Proposal for Supplement 5 to Regulation No. 129 (Enhanced Child Restraint Systems)

Submitted by the Working Party on Passive Safety *

Supplement 5 to Regulation No. 129 (Enhanced Child Restraint Systems (ECRS))

Figure 1

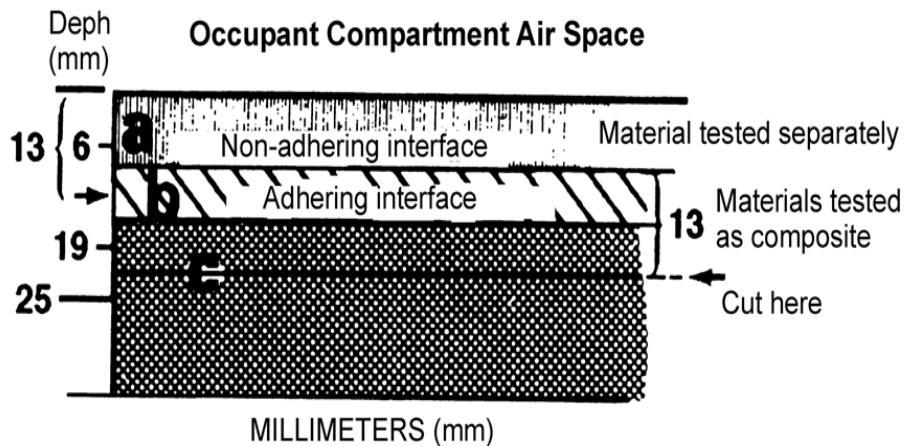
"Occupant compartment air space" means the space within the occupant compartment that normally contains refreshable air.
2. Material selection (see Figure 1 below)
 - 2.1. Any portion of a single or composite material which is within 13 mm of the occupant compartment air space shall meet the requirements in paragraph 6.1.6.
 - 2.1.1. Any material that does not adhere to other material(s) at every point of contact shall meet the requirements of paragraph 6.1.6. when tested separately

2.1.2. Any material that adheres to other materials at every point of contact shall meet the requirements of paragraph 6.1.6. when tested as a composite with the other material(s).

Material A has a non-adhering interface with material B and is tested separately.

Part of material B is within 13 mm of the occupant compartment air space, and materials B and C adhere at every point of contact; therefore, B and C are tested as a composite.

The cut is in material C as shown in Figure 1, to make a specimen 13 mm thick.

Figure 2

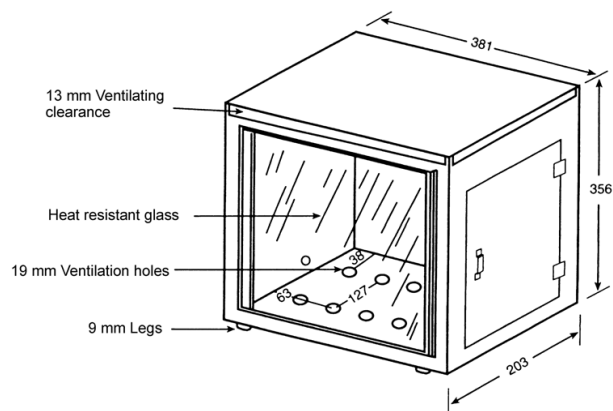
3.1. The test is conducted in a metal cabinet for protecting the test specimens from drafts. The interior of the cabinet is 381 mm long, 203 mm deep, and 356 mm high. It has a glass observation window in the front, a closable opening to permit insertion of the specimen holder, and a hole to accommodate tubing for a gas burner. For ventilation, it has a 13 mm clearance space around the top of the cabinet, ten holes in the base of the cabinet, each hole 19 mm in diameter and legs to elevate the bottom of the cabinet by 10 mm, all located as shown in Figure 2.
